**Planning Commission Staff Report
July 20, 2026 Meeting**

**6600 NEW ALBANY-CONDIT ROAD OFFICE
FINAL DEVELOPMENT PLAN**

LOCATION: 6600 New Albany-Condit Road (PID: 222-000640)
APPLICANT: Rob Riddle
REQUEST: Final Development Plan
ZONING: Infill Planned Unit Development (I-PUD): 605 Neighborhood Office District
STRATEGIC PLAN: Village Center
APPLICATION: FDP-32-2026

404.775-02
May 21, 2026To: Lauren Sauter
City PlannerFrom: Matt Ferris, P.E., P.S.
By: Jay M. Herskowitz, P.E., BCEERe: 6600 NA Condit Rd.
Final Development Plan

Image: Proposed site layout, showing the buildings, pavement and parking, and general landscaping.

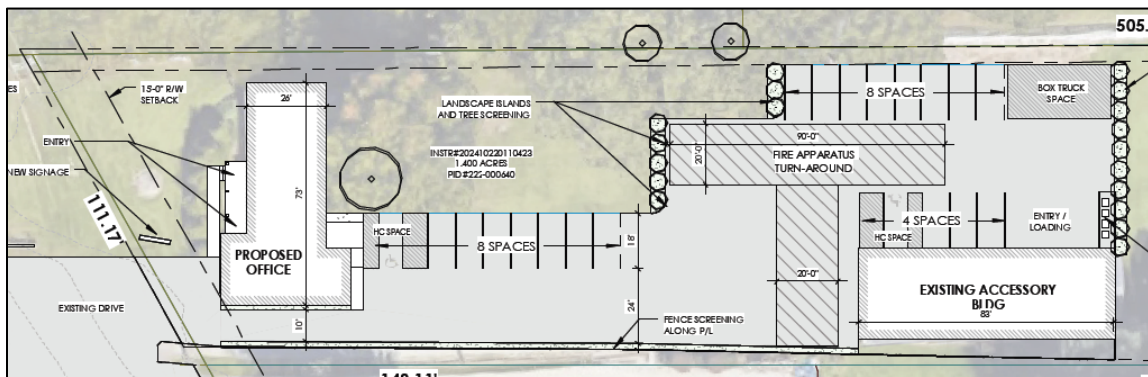
4. The distance of the pavement from the southern lot line is unclear. Staff recommends a condition of approval that the parking lot pavement be at least five feet away from the southern property line (condition #1).

3. A total of 20 parking spaces is proposed, which is the maximum number allowed (zoning text V(A)). All parking is located to the rear of the main building and no farther back than the easternmost portion of the accessory structure. Additionally, one loading space is proposed and one parking space is included at the northeast of the lot for a box truck.
4. The following parking requirements are applicable to the proposed development and are contained in C.O. 1167:

4. The applicant has proposed three blue spruce evergreen trees around the parking lot area; however, two deciduous canopy trees are required. Staff recommends a condition of approval that at least two of the three proposed evergreen trees be deciduous canopy trees, subject to staff approval (condition #4).

6. Surface parking areas must be screened from any right-of-way and adjacent properties by a minimum three- to five-foot-tall continuous planting hedge, fence, or wall unless adequate screening already exists (zoning text VII(C)). The proposed fence already screens the proposed parking lot from view by the adjacent parcel to the south; six-foot-tall arborvitae landscape screening is proposed along the eastern boundary of the pavement in addition to the existing forested area screening the site from Windsor.

1. The parking lot pavement shall be at least five feet away from the southern property line.
2. A bike rack shall be installed on the site.
3. All landscaping requirements shall be met.
4. At least two of the three proposed evergreen trees shall be deciduous canopy trees.
5. The Engineer's comments regarding both the final development plan and Traffic Access Study shall be addressed by the applicant.

Re: 6600 N.A. -Condit Rd
Traffic Access Study
Review Memo

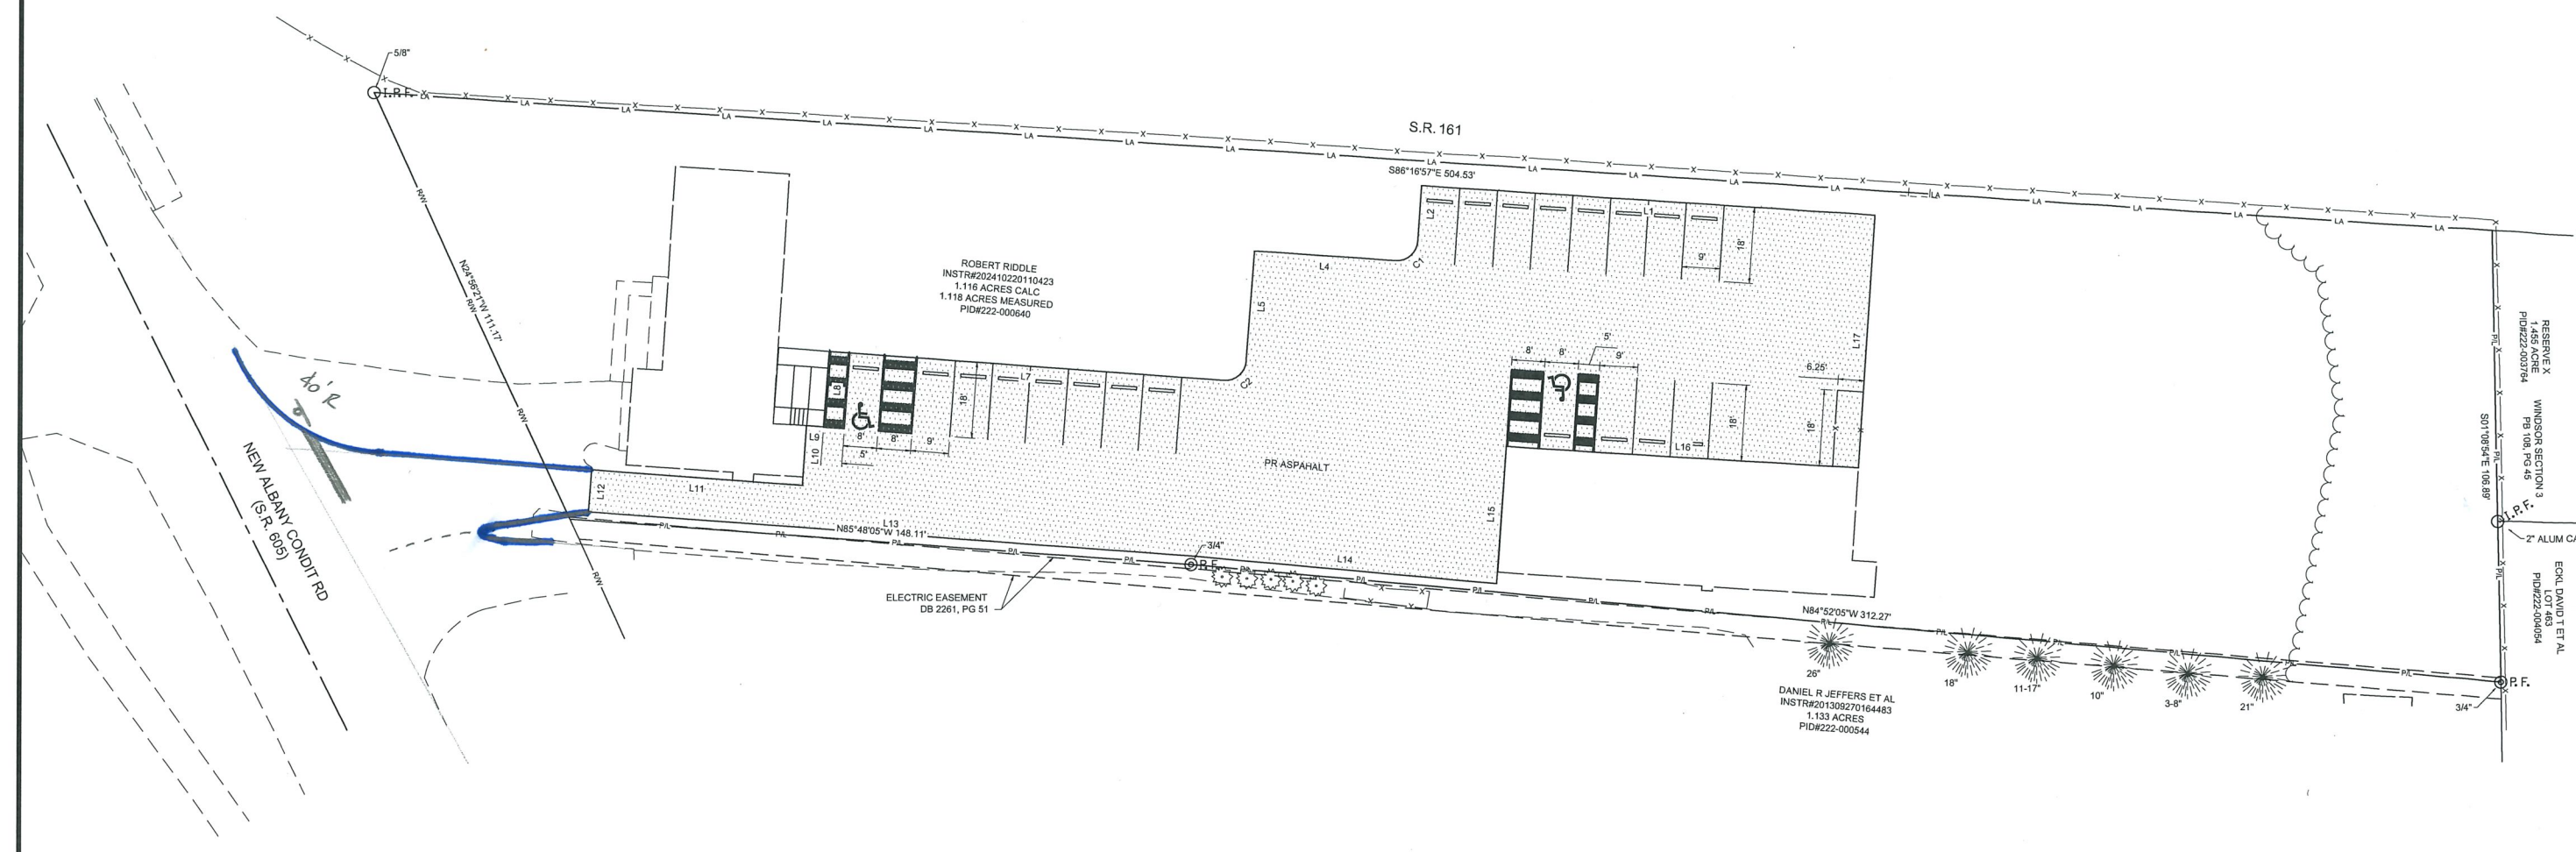
- We agree with the methodology, analyses and volumes/growth rate used by C-M in the preparation of the TAS report
- We concur with results on the turn lane warrants — no turn lanes are needed on NA-Condit Road because of the redevelopment of this site as a small office.

- Capacity analysis results at the office driveway intersection are acceptable for the redeveloped site.
- The horizontal sight distance review shows a slight overlap/conflict with the existing guardrail on the north leg of the intersection. We would like C-M to verify in their driveway design that the driveway's vertical profile does not preclude westbound office patrons from seeing northbound over the existing guardrail when exiting. Top of rail height is typically a 31" and standard driver eye height is 42". Due to the noted elevation drop of the existing SFR driveway on Streetview, please verify that the clearance is enough for motorists to see over the guardrail as they wait to pull out. If not, the city may want to request a slight buildup on the first portion of the driveway to ensure vertical clearance is available to address this.

- EPF would still like to review the site driveway design on behalf of the city for this site when submitted plans are available
